**LANCASTER COUNTY PLANNING COMMISSION
County Council Chambers, County Administration
Building, 101 North Main Street, Lancaster, SC 29720**

- c.** SD-2021-2450 Pettus Pond
Application by Eastwood Homes, Jane Pettus and Anthony Haltom for approval of a Preliminary Plat for three parcels totaling approximately 61.24 acres located at or adjacent to #10925 and #10822 Pettus Farm Road and Old Pettus Place, respectively, (TMs 0003-00-051.00, 0003-00-052.00, and 0003-00-052.06), for a single-family residential development of 99 lots.

Pettus Pond Preliminary Comments
Response to Comments
Date of Comments: November 9, 2021
Date of Response: December 7, 2021

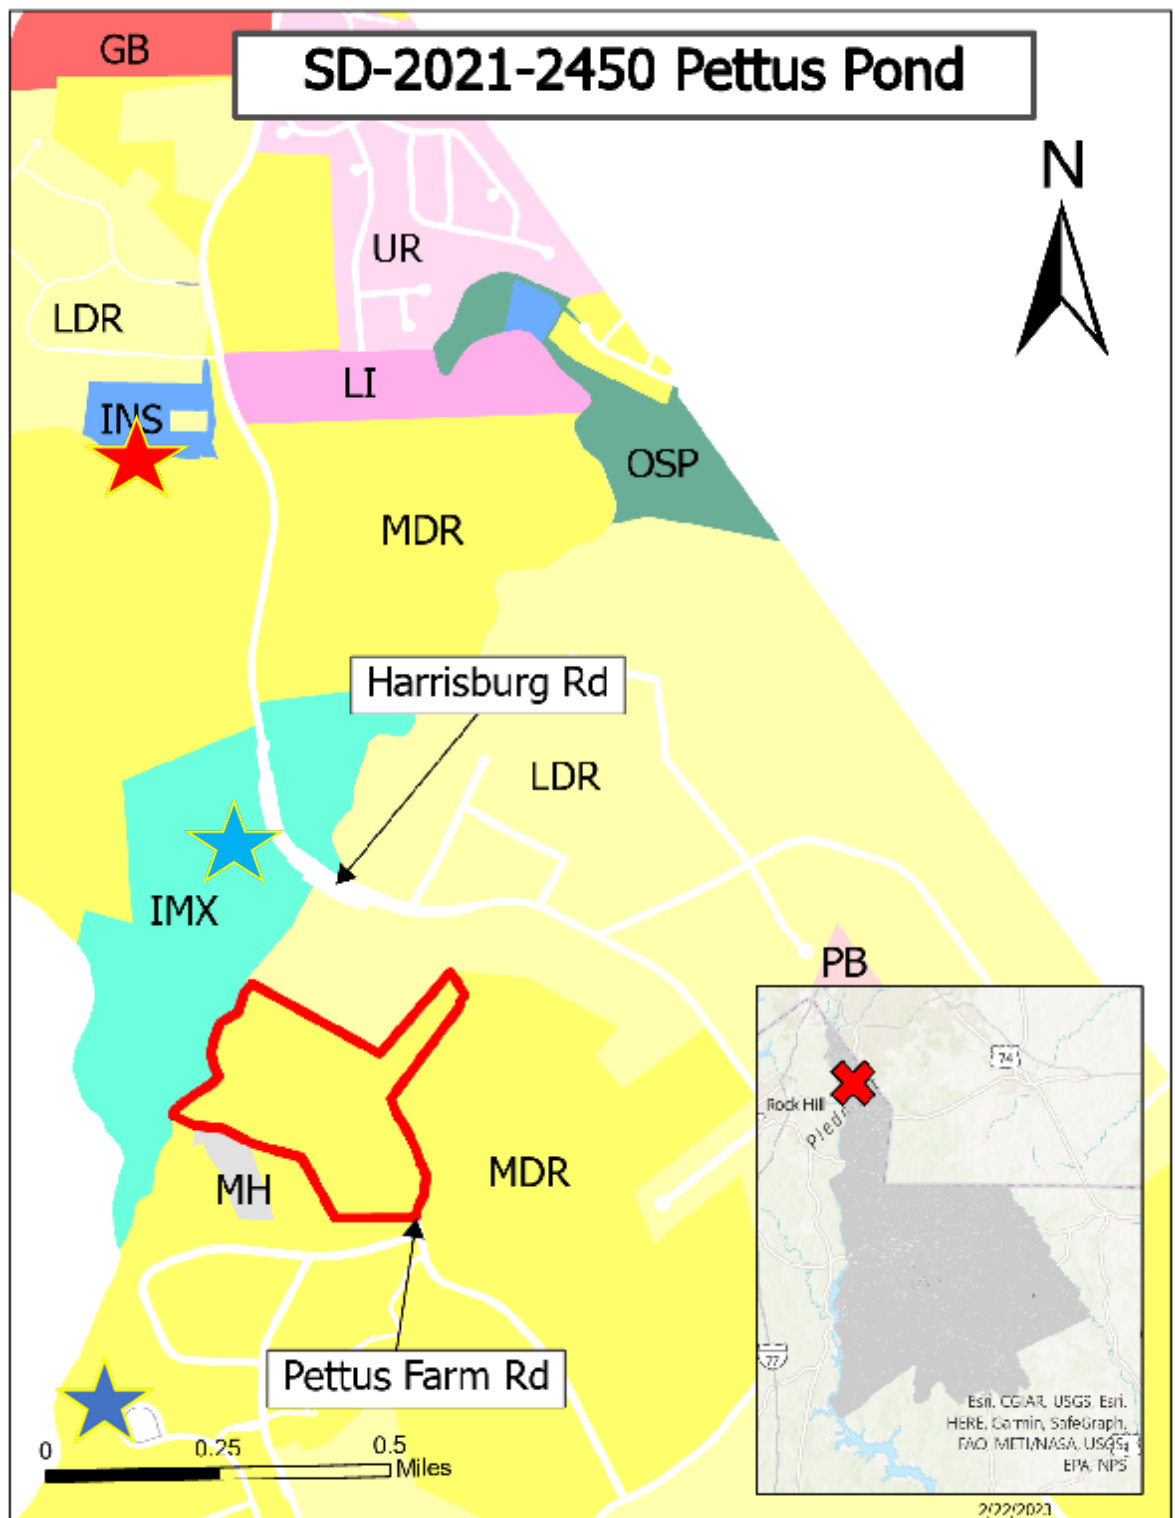
2. Show a 30' SSE connecting to the proposed 40' SSE along the southern property line to the adjacent properties:

- Parcel 0003-00-052.05
- Parcel 0003-00-052.11

[A 30' SSE connecting to the proposed 40' SSE has been added for noted adjacent properties.](#)
